RE: .

At your request a visit was made to the referenced address on May 4th, 2026 to inspect the structure, with particular attention to items recently noted in a prior home inspection report. Public property records indicate this house was built in 1977. With homes of this age, one can expect there to be some framing conditions that do not meet today's Code requirements. With that in mind, the repairs recommended in this report are intended to prevent further deterioration and address damaged areas or areas of insufficient support that may influence the safety and performance of the structure under normal use. The following items were noted at the time of the inspection with any photos relevant to that item immediately following:

Garage Ceiling Repair Plan

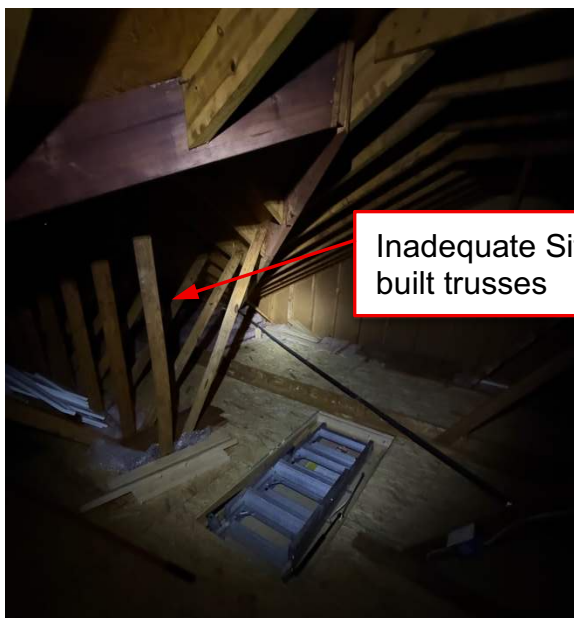
1. In the front attic, the valley rafter at the center bears on a single 2 x 4 plate. Although this condition raised concern in the home inspection report, the member is relatively lightly loaded and the existing bearing condition is sufficient to support the imposed loads.

Damaged girder

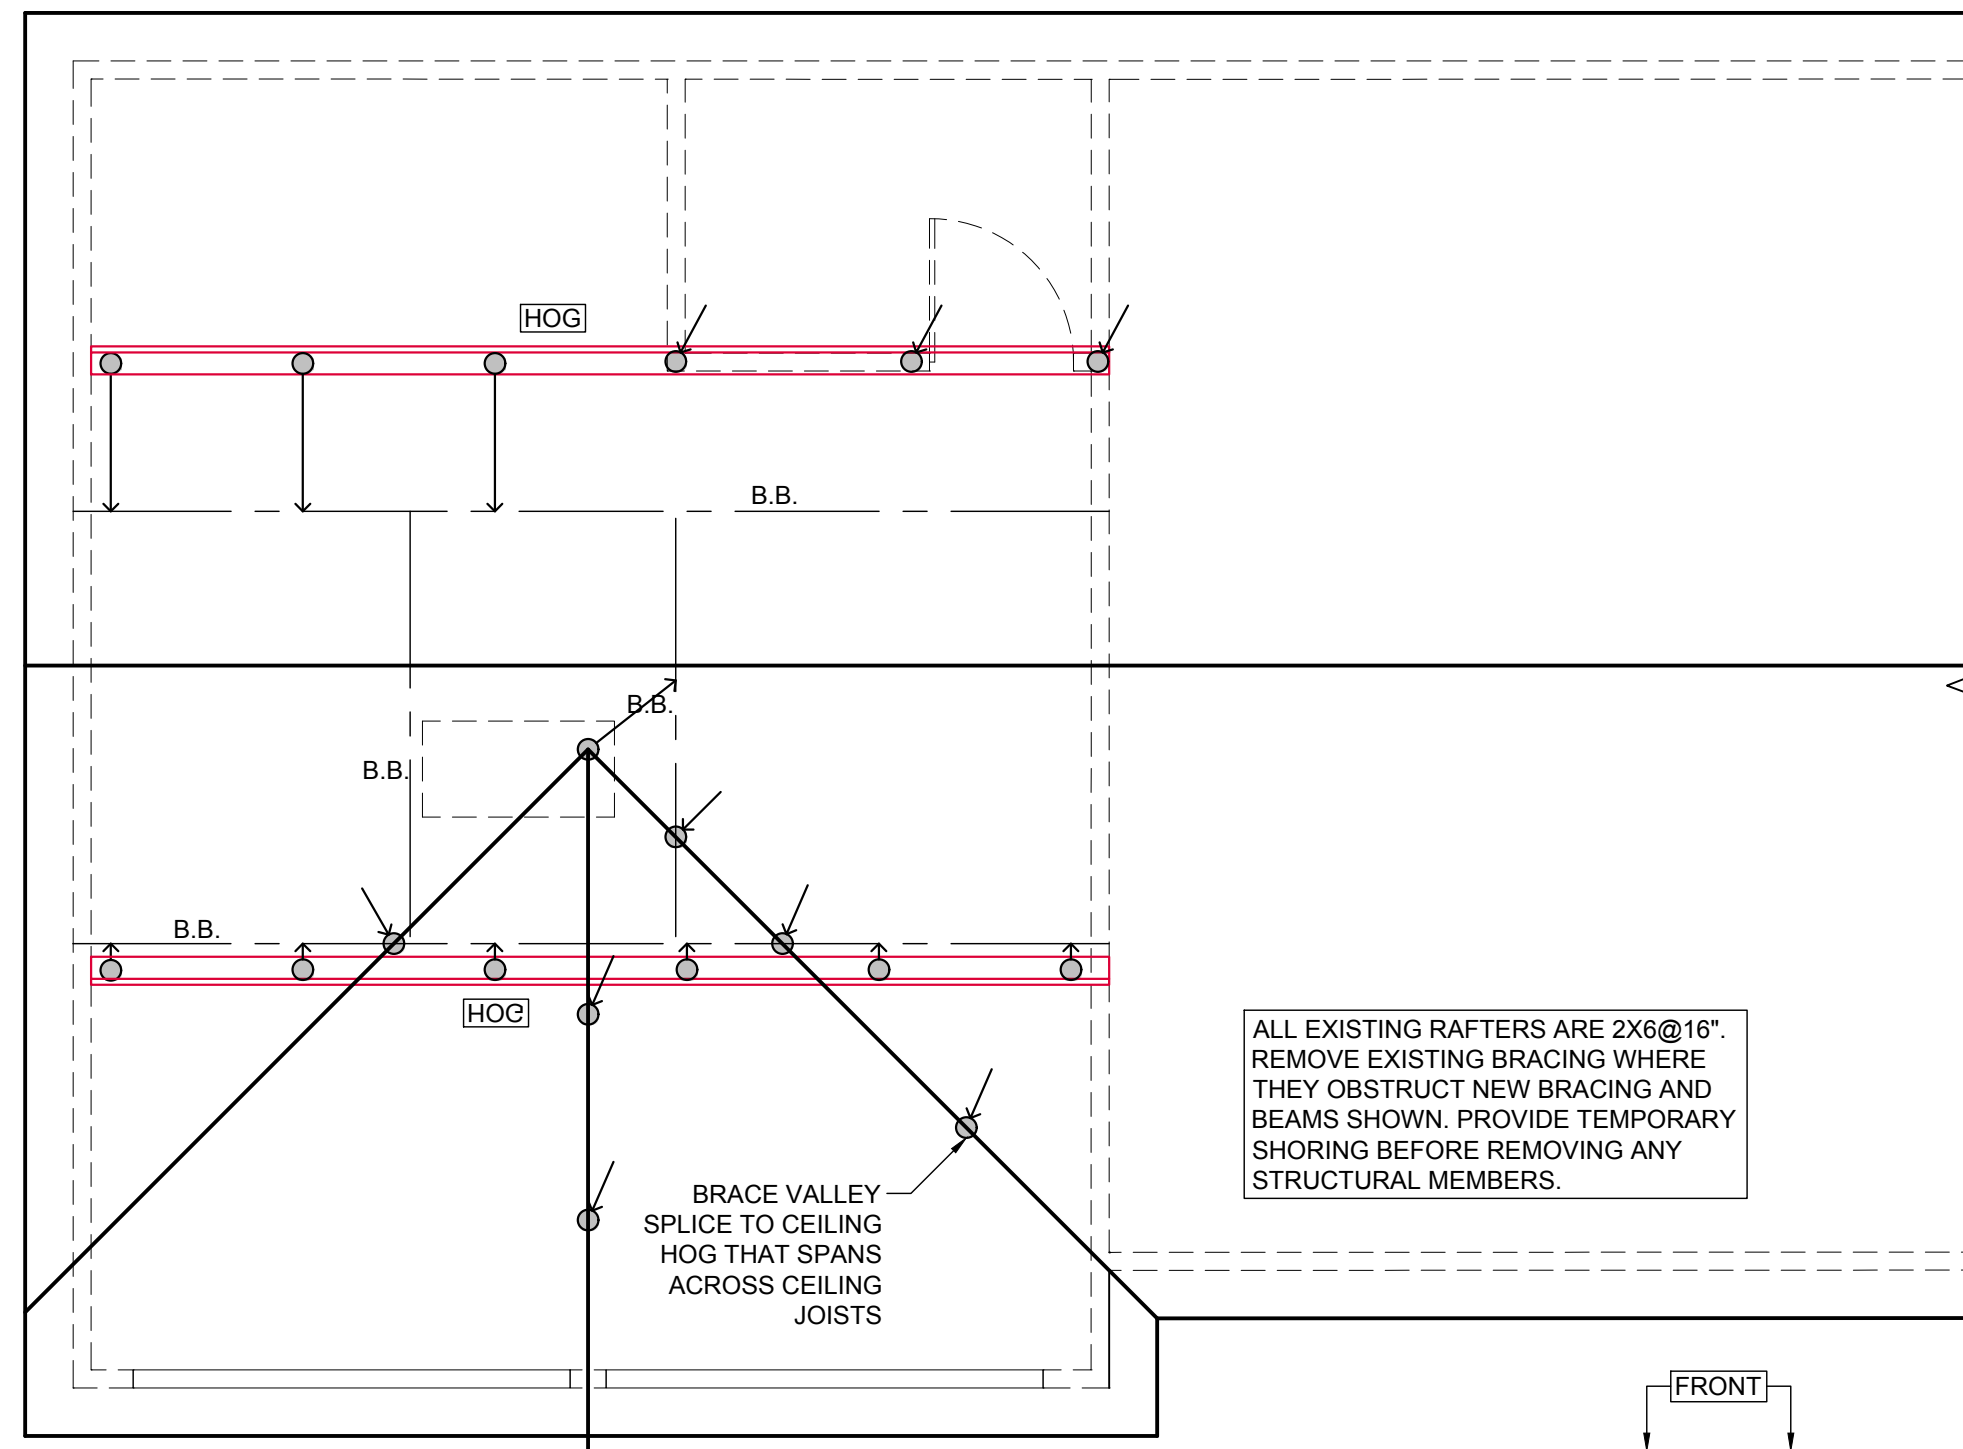
9. At the girder supporting the front hallway wall on the right side of the home, a section near midspan exhibits structurally significant fungal decay. This condition should be addressed either by replacing the affected girder section between piers with a comparable treated double 2 x 10 member or by installing an intermediate masonry pier to reduce the effective span. If a new pier is installed, the deteriorated lower 2 inch portion of the girder should be removed to expose sound wood, and the new support should consist of 8 x 16 CMU bearing on a 22-inch by 22-inch by 7-inch concrete footing. Joists should then be securely connected using Simpson A35 brackets as previously described. See the photo on the following page.

10. Beneath the bathroom, the OSB subflooring has been installed with improper orientation. To address this, install 2 x 4 ladder blocking at 24 inches on center perpendicular to the joists. Blocking should be secured with toenails or Simpson LU24 hangers to provide adequate support to the subfloor panels.

11. At the front foyer, a floor joist has been excessively notched to accommodate a supply duct. Reinforcement is recommended by sistering a 2 x 6 member along the upper portion of the joist to restore structural capacity. See the photo on the next page.

Add blocking
